NOTICE UNDER SECTION 96 OF ACT III OF 1901.

I beg to inform you that I intend building a house
on plot No. 2249226Survey Sheet No. A-18 situate in Sye Ellapa
Da Street, Napier Quarter.As required by the rules of the Municipality, I beg to submit herewith a
plan of the same for your approval.

I beg to inform you that I intend building a house
on plot No. 53Survey Sheet No. A-20 situate in Quornal
Street, Mafice Quarter.As required by the rules of the Municipality, I beg to submit herewith a
plan of the same for your approval.

PLAN OF PROPOSED BUILDING.

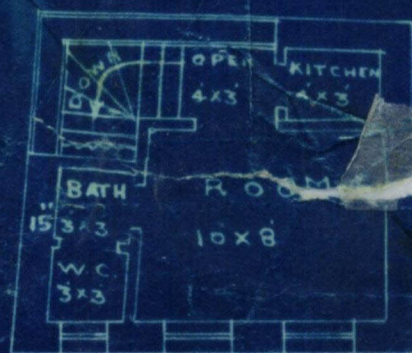
*The plot is too small to
have a living room with all
sanitary conveniences on one story*

Building Surveyor's Report Sir, With reference to this I beg
to report that no arrangement of draining & water is shown
The plot is too small for having a shop & a house.

Remarks Sir, Portion taken acquired out of plot No. 22
A 28. Napi & there was Collector's order the
convenience to be kept on the ground floor.
but nothing has been done. Request your order.
Yours truly
Nathu

Land Surveyor why is the whole of the plot not attached?
Attach it at once & see up with drawing sheet.

Reply that the plot is too small on which
to erect a sanitary building. The plan
is disapproved.

At 28 Napier Quarter, Messrs. Mulehand
Godhanda & Eulhanda Meeray are
informed that the plot is too small
which to erect a sanitary building.
The plan is disapproved.
